ADDENDUM NO. 2

DATE: February 24, 2023

RE: Dickinson Park Sports Fields Renovations
Project No.: 21-1558

Drawings: (all revisions have been clouded and tagged with a delta-2)

REFERENCE SHEET & LIFE SAFETY PLAN

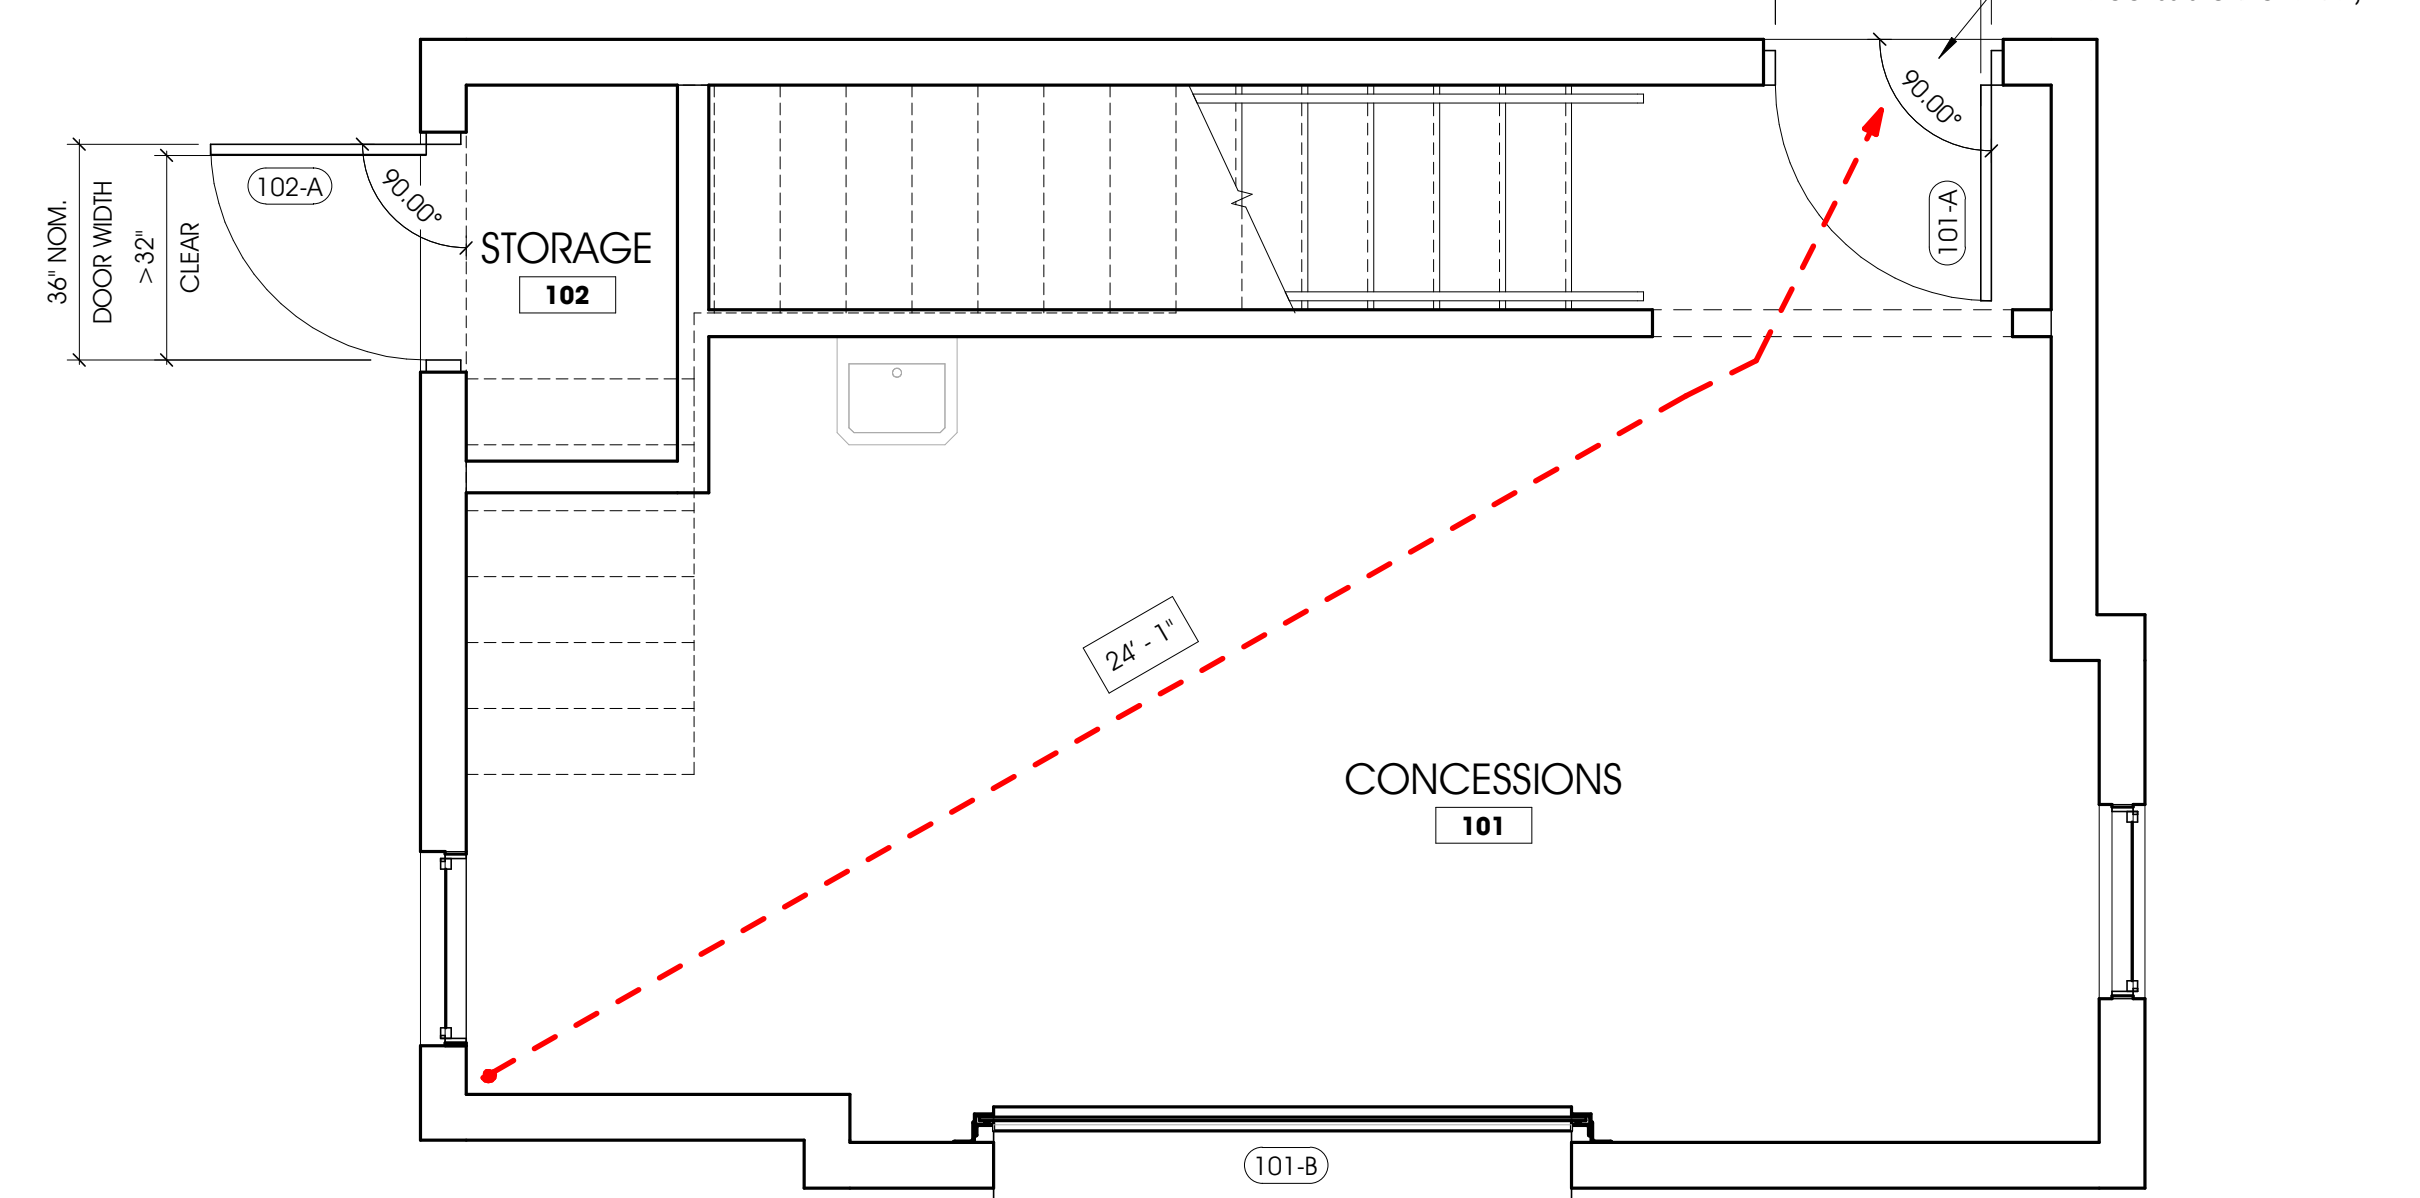
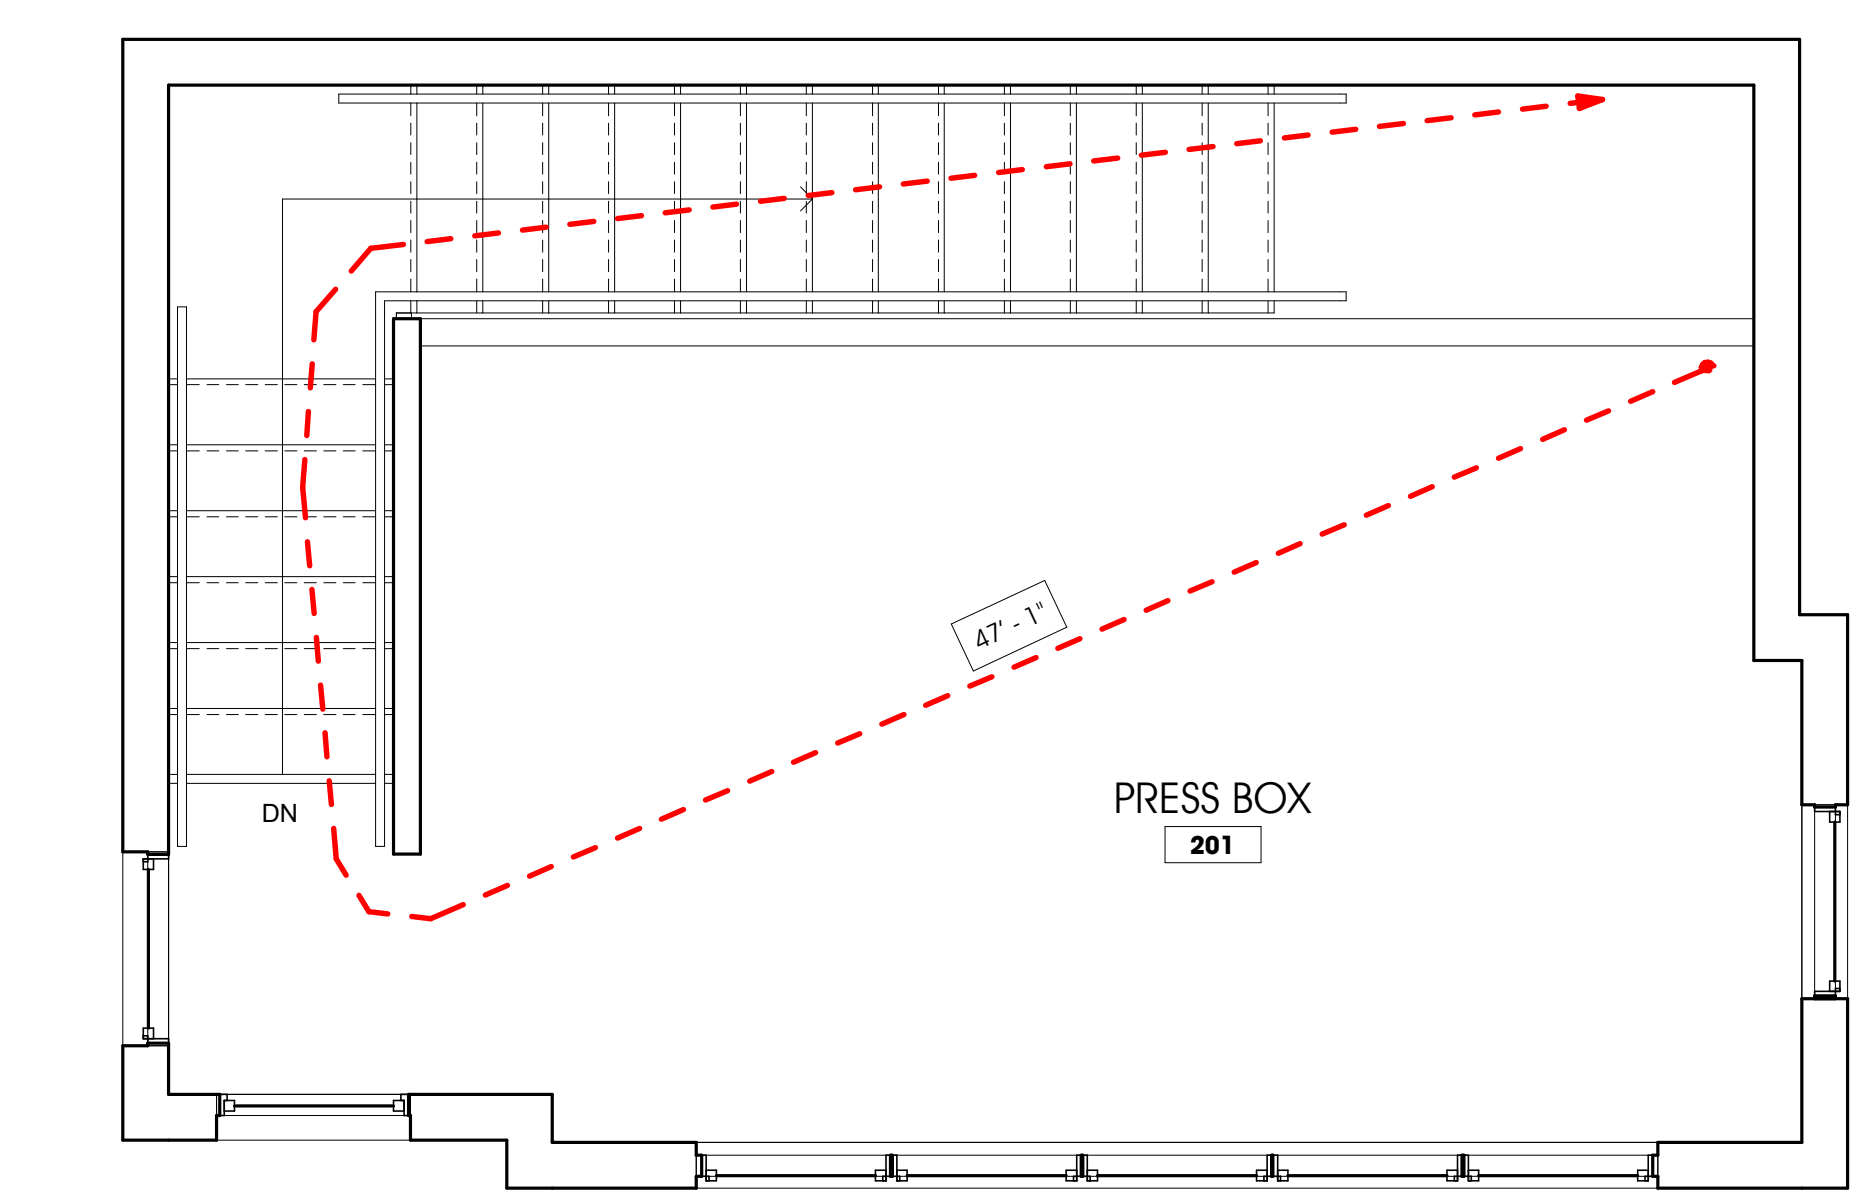
- a. Flipped the position of the terms "Negligible" and "47'-1" " previously reversed in error under General Notes – Life Safety
12. Alternate 1, Sheet S1.0
